JENKINS & HOGIN, LLP
A LAW PARTNERSHIP

October 8, 2009

Re: City of Malibu Comments on proposed amendment to the Water Quality Control Plan for the Coastal Watershed of Ventura and Los Angeles Counties (Basin Plan), to prohibit on-site wastewater disposal systems in the Civic Center Area of the City of Malibu

Revised Plot of Compliant and Non-Compliant Test Well Results

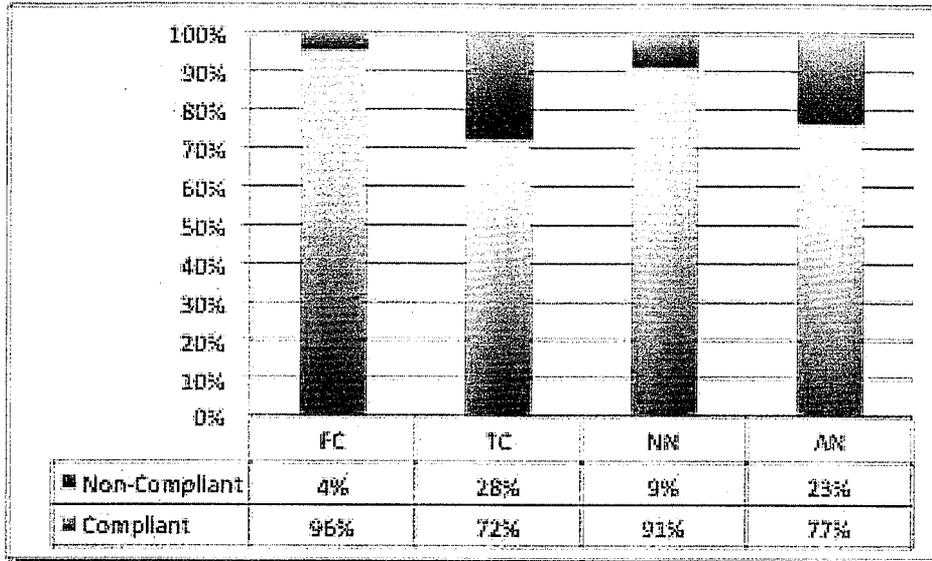
5	T2-7 and T2-73 and on		Looking at the graphs of test results with time at the end of the memo, and undertaking a more objective assessment of Pass or Fail whereby one failing test does not automatically fail the well, a significant number of wells are compliant with water quality standards. (see the figure titled <i>Revised Plot of Compliant and Non-Compliant Test Well Results</i> in Appendix 2-1 of this review memo).
5	T2-7	8	There is no drinking water quality MCL for ammonia, therefore this paragraph should be deleted from the document. Similarly, the last column should be omitted from Table 1.
6	T2-5	2	Section 6 Conclusions: All of the data reviewed in the Technical Memorandum is in the upper aquifer, and therefore is not pertinent to the lower aquifer, which was historically pumped as a water supply, but discontinued due to apparent saltwater intrusion. See the figure titled <i>Total Dissolved Solids Lower Malibu Wells Trend Line Graph, Malibu Water Co., prepared by Pomeroy & Assoc. March 1961</i> in Appendix 2-1.

Above: Plot of Compliant and Non-Compliant well test results after a more objective re-examination of the plotted test results from Technical Memo #2, assuming that one failing test result does not fail the well, but a pattern of failing test results does.

Below: The Board's plot from Technical Memo #2, to illustrate the extremely conservative nature of the Board's characterization.

Figure 2R: Chart of Geometric Means of Enterococcus Density (MPN/100 mL) for 20 groundwater wells in the Civic Center area from Stone 2004 Study

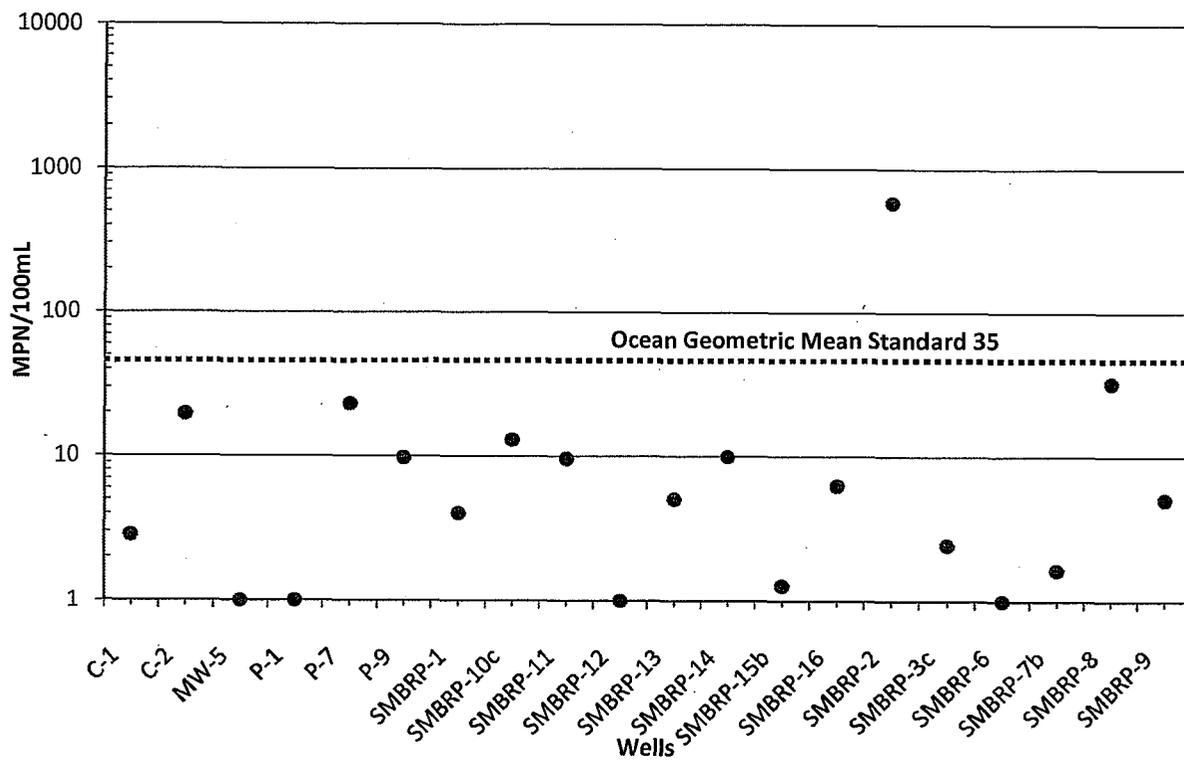
3	T3-5	Fig 2 & 3	<p>Section 3 Results – Bacteria in Groundwater</p> <p>Figures 2 & 3 show single sample results, and compare them to recreational water geometric means. The geometric mean standard should be compared to geometric means of measurements in individual wells. We have prepared two revised figures titled <i>Figure 2R: Chart of Geometric Means of Enterococcus Density (MPN/100 mL) for 20 groundwater wells in the Civic Center area from Stone 2004 Study</i> and <i>Figure 3R: Chart of Geometric Means of Enterococcus Density (MPN/100 mL) for 27 permit monitoring wells in the Civic Center area</i> (Appendix 3-1), with the geometric means of sample results from each well plotted with the geometric mean standard.</p>
3	T3-5	Fig. 2	<p>Data are from Stone's 2004 Risk Assessment report. The LARWQCB provides no documentation to infer that these wells represent current groundwater quality conditions.</p>

Figure 3R: Chart of Geometric Means of Enterococcus Density (MPN/100 mL) for 27 permit monitoring wells in the Civic Center area

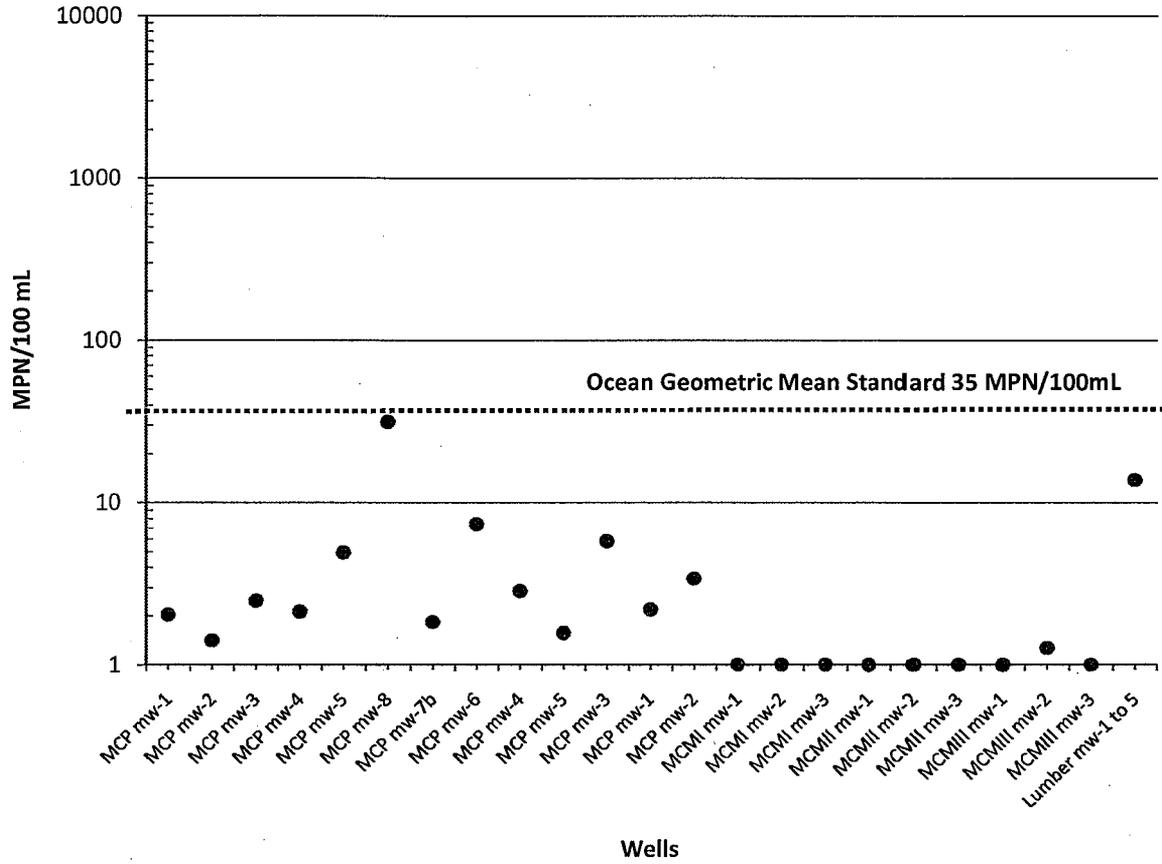
3	T3-5	Fig. 3	<p>Figure 3, Page T3-5 shows a plot of maximum enterococcus bacteria results from the 27 surviving wells in the CC area. The use of these data is dubious because as shown in the review of Memo #2, the Board's use of "Maximum" frequently means one reading out of 5 years' worth of data for most of the wells, and/or fails to account for a managed system whereby OWDS repairs made in 2004 or 2005 result in consistent enterococcus values well below the action levels. The Board's continuation of this biased use of the data from Technical Memo 2 in Technical Memo 3 calls into question the entire conclusion of this Memo.</p>
3	T3-6	2	<p>Section 3 Results Bacteria in Surface Water - The statement: "<i>Malibu Civic Center groundwater discharge is a possible source of increased levels of enterococcus in the Lagoon.</i>" is misleading because groundwater monitoring has shown that not all groundwater in the Civic Center Area flows into the lagoon (see map titled "Groundwater Wells and Groundwater Recharge Areas in Malibu Study Area", Appendix 3-1).</p>

Figure 1. Total coliform bacteria levels station S-01 Surfider Beach

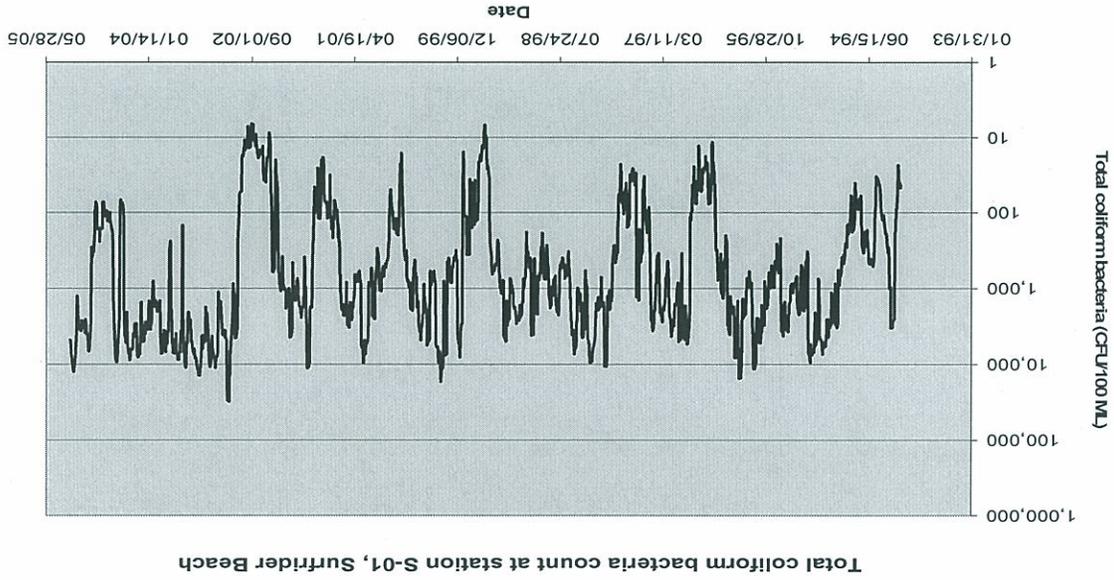
It is difficult to determine from this Figure whether there is any significant increase or decrease in bacteria levels pre- and post-prohibition. In order to better examine whether there was any significant change pre- and post-prohibition, the data and graphs using the 1000 CFU/100 ML threshold is more helpful.

Figure 3. Pre- and post-prohibition bacteria levels, Surf Rider Beach

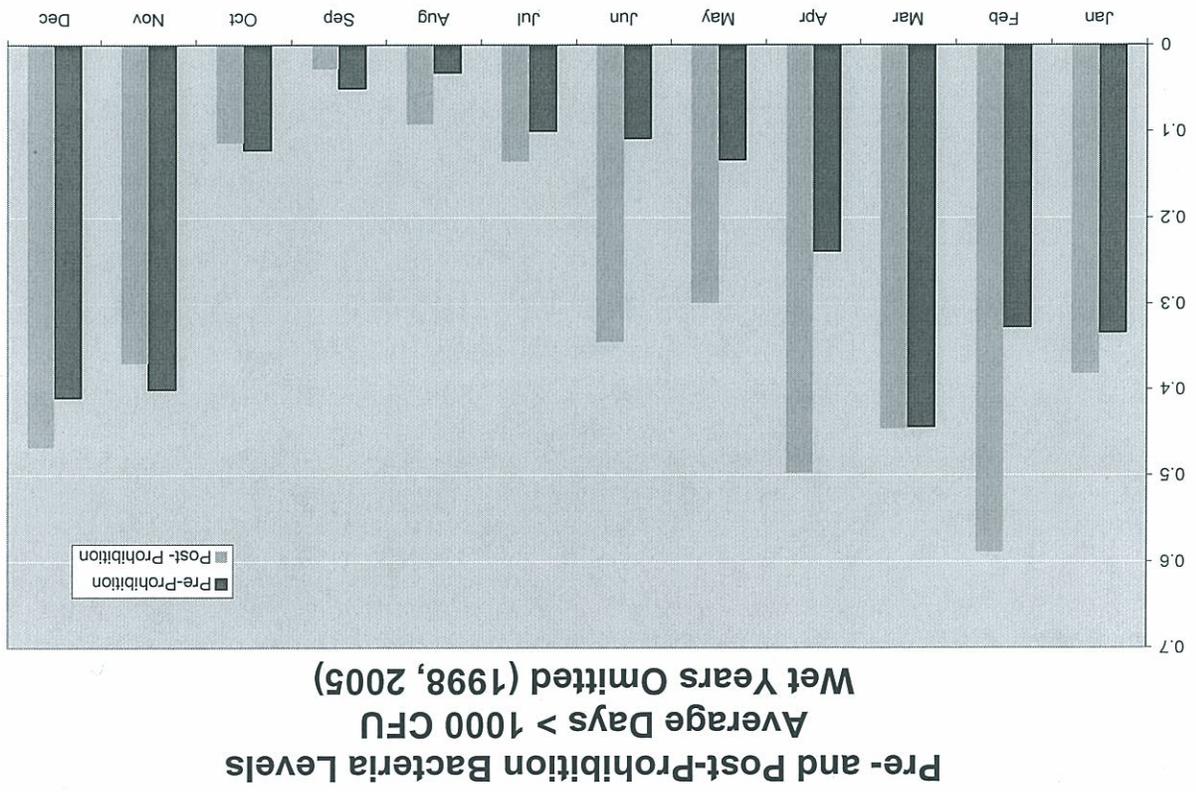
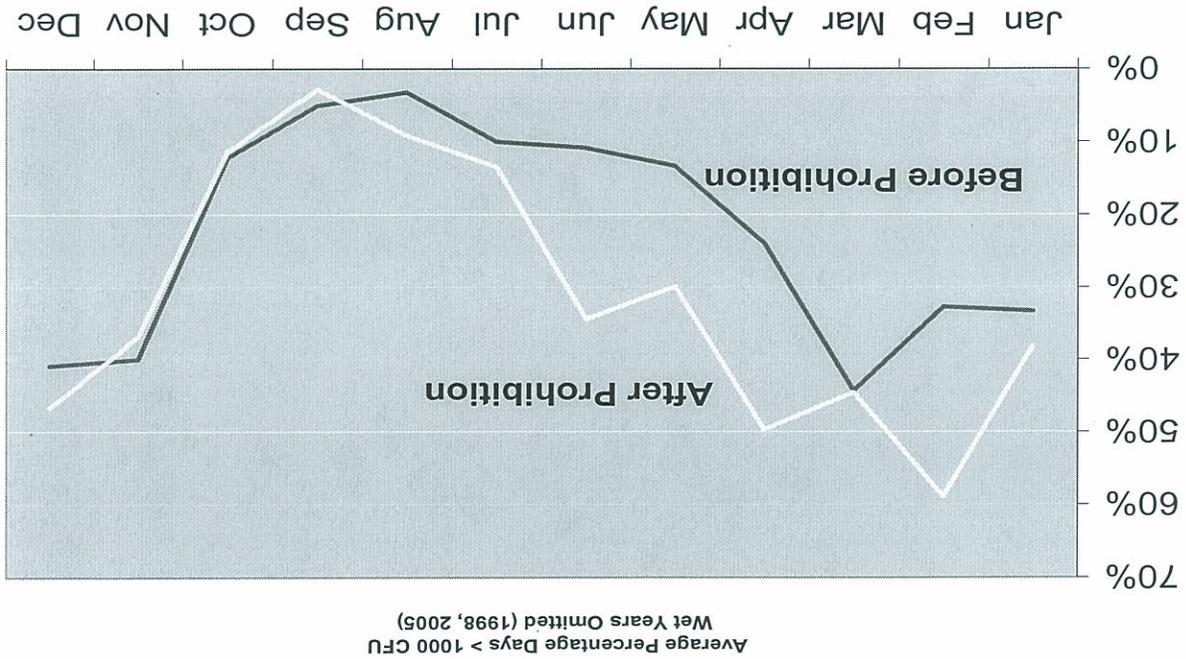
Figures 2 and 3 show that there was a rise in the number of days per month post-prohibition that exceeded the 1000 CFU threshold compared to pre-prohibition. Note that this result is true for the months of the year when there is substantial flow in the creek, primarily January through June. For example, for the month of February, the post-prohibition period has almost 60% of days exceeding the threshold, while during the pre-prohibition period the value is closer to 30%. It is worth noting that Tapia's contribution to flows in the winter were lower in the post-prohibition period than before. The percentage of days exceeding the threshold was higher in the post-prohibition period for months December, January, February, April, May, June, July and August. The month of March is unique in the pattern observed; for that month the percentage of days exceeding the threshold is approximately equal pre- and post-prohibition. In short, none of these results support the premise that the flow prohibition was effective in reducing

bacteria levels at Surfside Beach. On the contrary, they suggest that bacteria levels and the number of unhealthy days for bathers rose.
